Docket #16 BAR #2019-00021 Old and Historic Alexandria District March 6, 2019

ISSUE:	Certificate of Appropriateness for alterations						
APPLICANT:	Wendy Battaglino						
LOCATION:	Old and Historic Alexandria District Address: 117 South Fayette Street						
ZONE:	CL/Commercial low zone

STAFF RECOMMENDATION

Figure 1: Second floor windows, front façade (115 & 117 South Fayette Street)

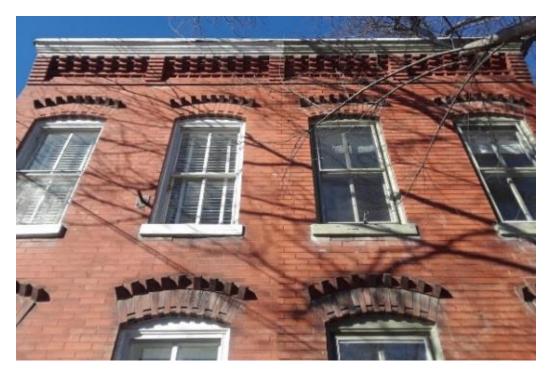
From the sidewalk on South Fayette Street staff could determine that the three windows on the building's primary (east) façade and the two windows on the south side which are part of the main block are original to the building and are in good condition. The two-over-two wood windows feature a thicker muntin between the lights which is commonly found on buildings from this period and they are identical to the twin-dwelling neighbor's windows at 115 South Fayette Street (Figures 1 and 2). The street facing sashes and frames of the visible windows are in good condition with no sign of wood rot, broken glass, or split parts. The windows do not appear to be painted shut and seem to be operable (Figures 3 and 4). Staff could not identify original wood pegs or the existence of mortise and tenon joints due to several coats of paint on the exterior and staff was not granted access to the interior of the house to definitively date the windows. While not binding upon the BAR and referenced here only as a nationally accepted preservation practice, the Secretary of the Interior's Standards for Rehabilitation <u>does not</u> recommend: *Replacing windows solely because of peeling paint, broken glass, stuck sash, and high air infiltration. These conditions, in themselves, are no indication that windows are beyond repair.*¹

- 1. Repair and retain the original two-over-two wood windows on the main block;
- 2. Defer approval of replacement of the windows and doors on the side elevation (except for one second floor window) until the applicant provides sufficient evidence to demonstrate to staff that they are not original and/or are beyond reasonable repair.
